# TOPANGA LAGOON RESTORATION PROJECT

## Final Environmental Impact Report

## Response to Comments

## 2.3 Hydrologic Modeling Master Response

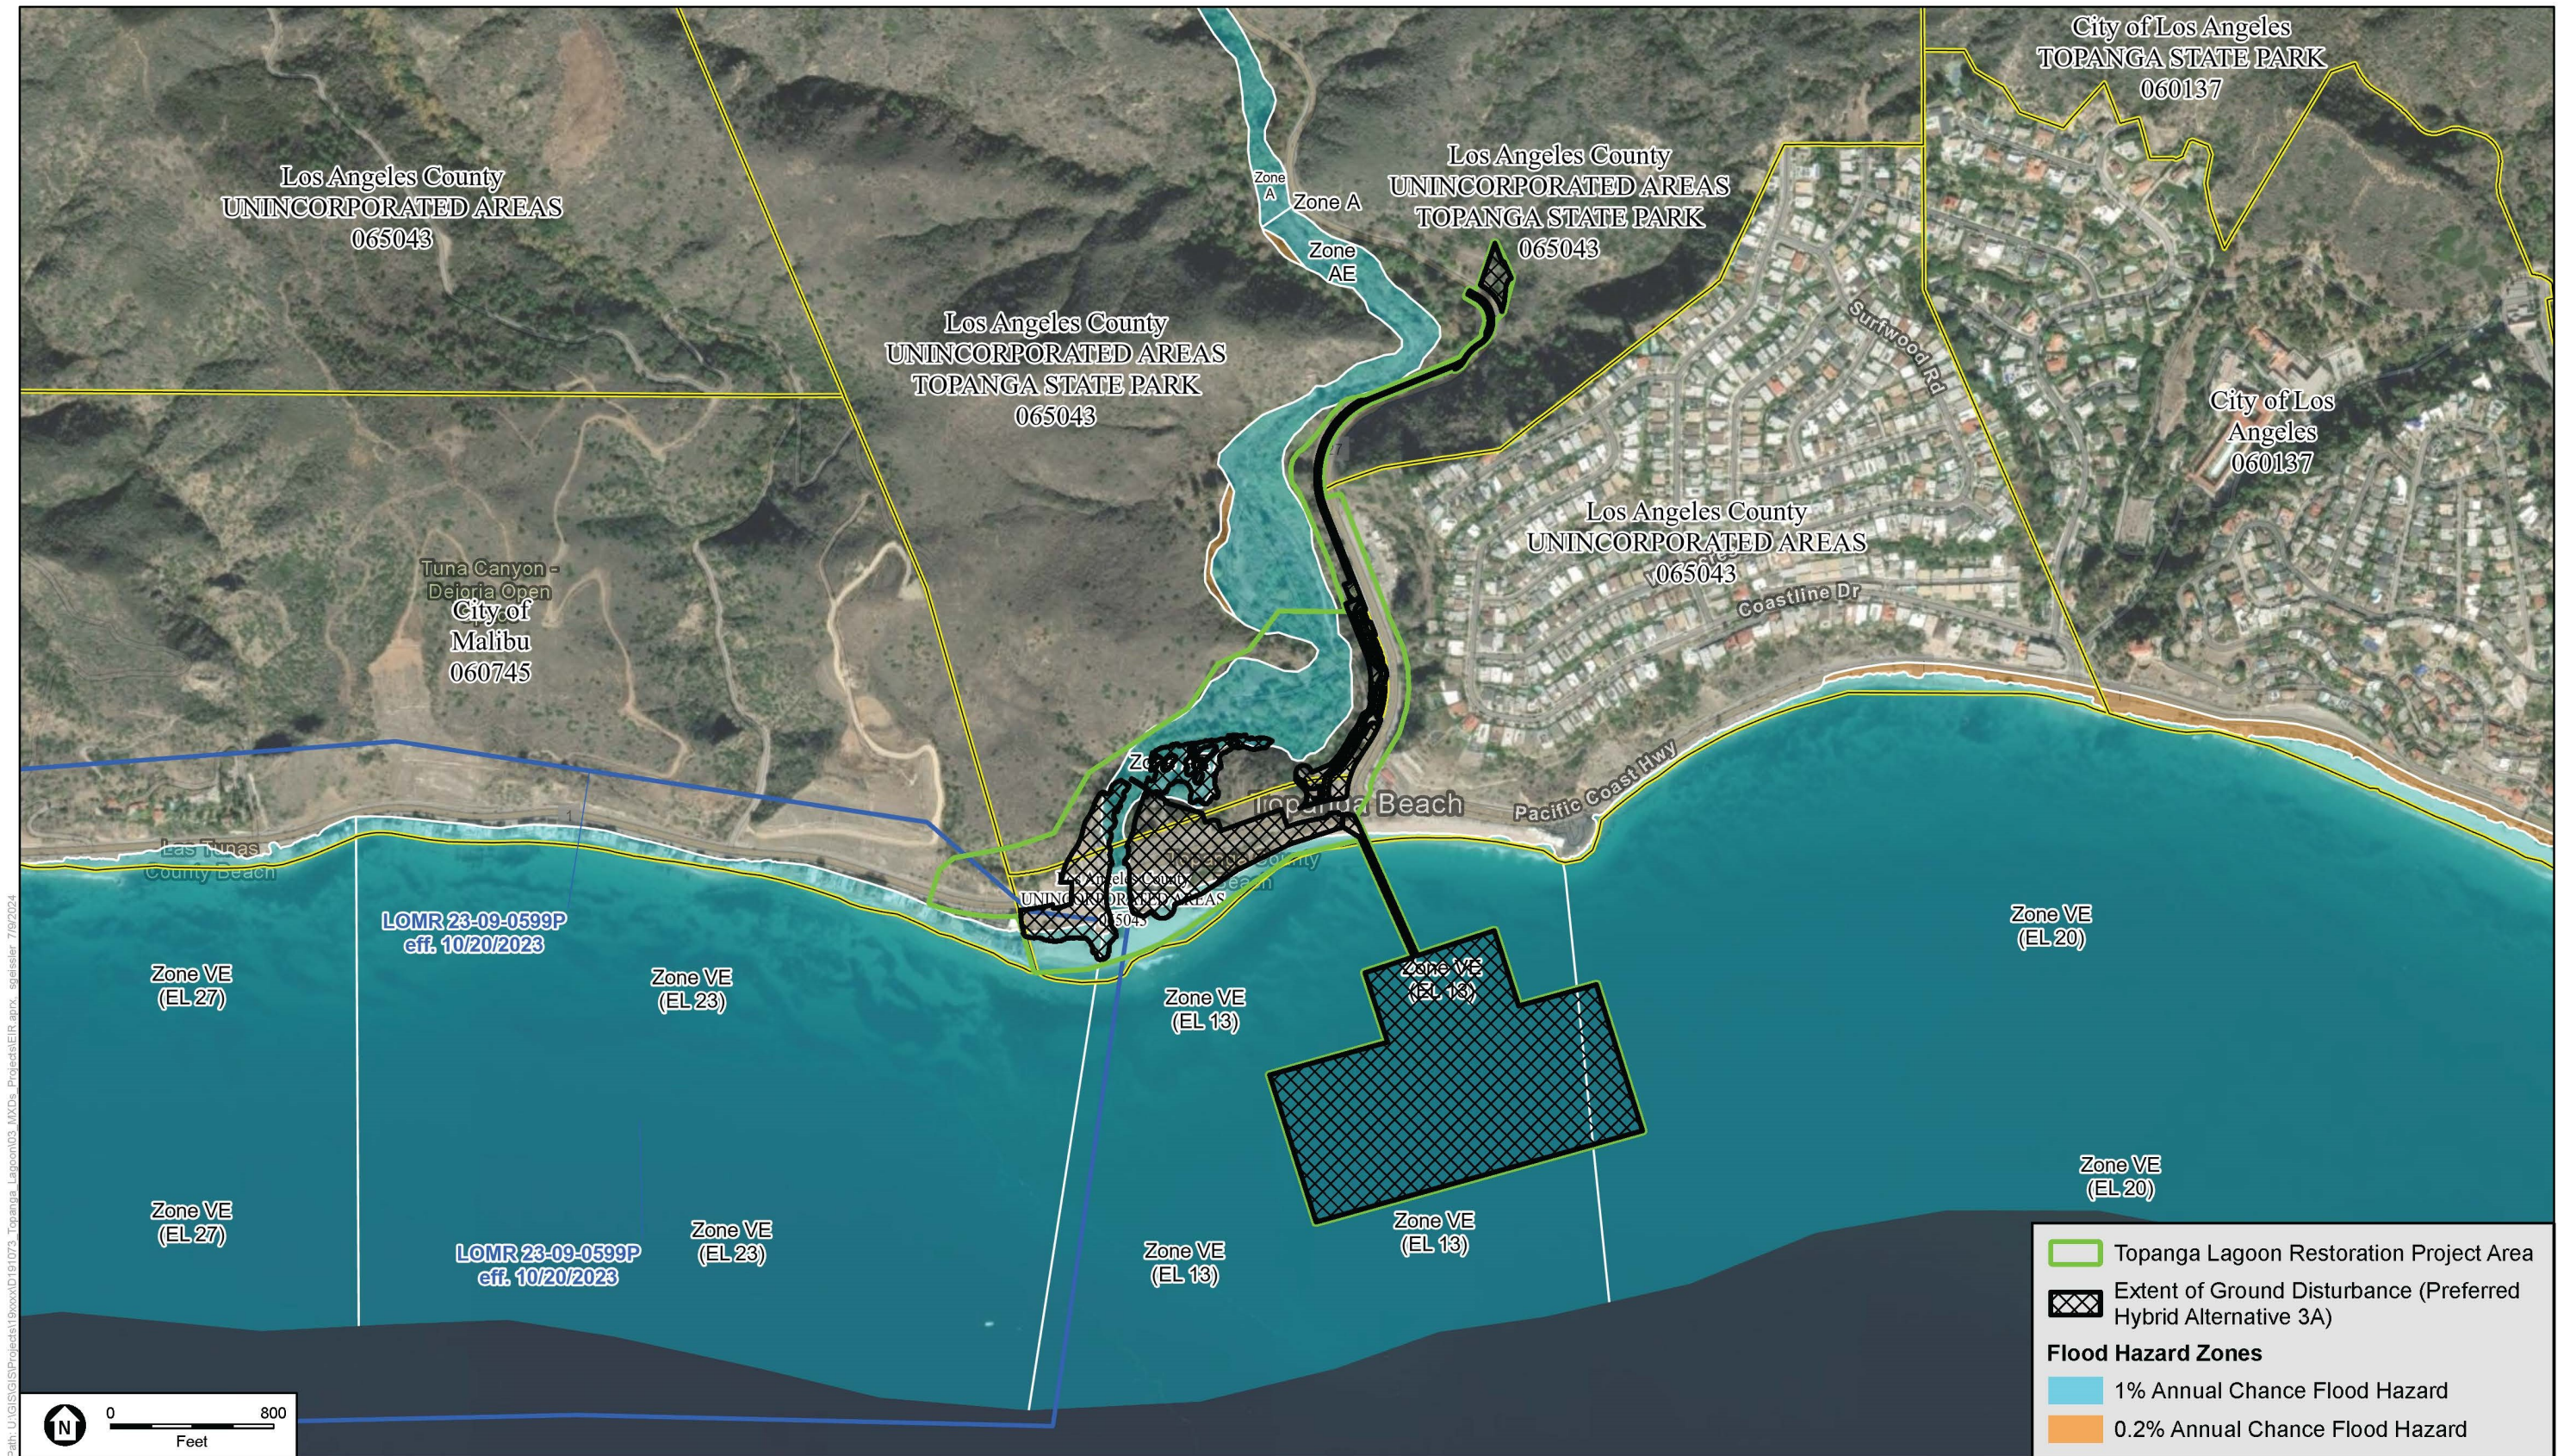
Comment Number	Comment	Response
AG 11-17	<p>Page 2-12 notes that all the proposed Build Alternatives would remove existing locally derived fill material for beneficial reuse by strategically placing it in the nearshore to naturally help renourish and restore the littoral cell, which would provide additional resilience to the beach both downcoast and within the Project area. Based on previous statements in the DEIR, the nearshore placement of sediment could provide up to 156,000-256,000 CY of suitable grain size material to renourish severely eroded areas between Mastro's Point and Will Rogers State Beach, which are outside of the Project area. Please ensure this information is consistent across the DEIR. If resilience benefits are anticipated within the Project area, please elaborate how in the appropriate sections. (Marine Biological Resources, Page 3.11-29, Alternatives 2,3, and 4 Build Alternatives</p>	<p>The Draft EIR describes in Section 2.6.6 the options for on-land sediment disposal or near-shore beneficial reuse. Nearshore sediment placement is described as a means of providing beach nourishment down-coast while also reducing impacts to air quality and traffic caused by the offsite trucking and disposal alternative. The Draft EIR evaluates the impacts of near-shore placement in Section 3.11 Marine Biological Resources. The analysis is supported by <b>Appendix G</b>.</p> <p>A detailed assessment of the material to be excavated from the area was conducted and summarized in <b>Appendix G</b> Sediment Beneficial Reuse Study (Moffatt &amp; Nichol 2022), and Beneficial Reuse Soil Characterization (GeoPentech 2022), and the Sampling and Analysis Plan (M&amp;N 2023) process required by the U.S. Environmental Protection Agency (USEPA) and the US Army Corps of Engineers (USACE) Dredged Materials Management Team (DMMT). The analyses characterize the grain size range from soil samples taken on site and reports on chemical analyses conducted to determine suitability for beach nourishment. This process has led to agency conclusions that the material is considered "clean" from contaminants and is sufficiently similar in grain size to be deemed compatible with placement in the ocean. As a result, the Draft EIR concludes based on this analysis that the soils to be removed are suitable for beneficial reuse for nearshore placement to provide future beach nourishment.</p> <p>A nearshore morphology analysis was conducted to determine the most suitable placement site based on proximity and accessibility from the project site and balancing the marine environmental impact and beach nourishment benefits. A suitable location was identified southeast of the lagoon as shown in Figure 2-2. This site exhibits low presence of sensitive marine vegetation and invertebrates. The analysis concludes in Section 3.11-32 of the Draft EIR that the site appears to be suitable, pending approvals from the California Coastal Commission, National Marine Fisheries Service, and the US Army Corps of Engineers. The Draft EIR identifies mitigation measures MAR-1, MAR-2 and MAR-3 that would ensure impacts to the marine environment would be minimized.</p> <p>The placement of sediments southeast of the lagoon is downcoast. The prevailing currents move sand northeastward. As a result, Topanga State Beach would not benefit from the one-time nourishment action. However, beaches downcoast would benefit from the additional material. Once constructed, normal sediment transport from Topanga Creek would continue. The lengthening of the bridge would broaden the area of sediment deposition on the beach but would not change sediment loads delivered to the ocean compared to existing conditions.</p>
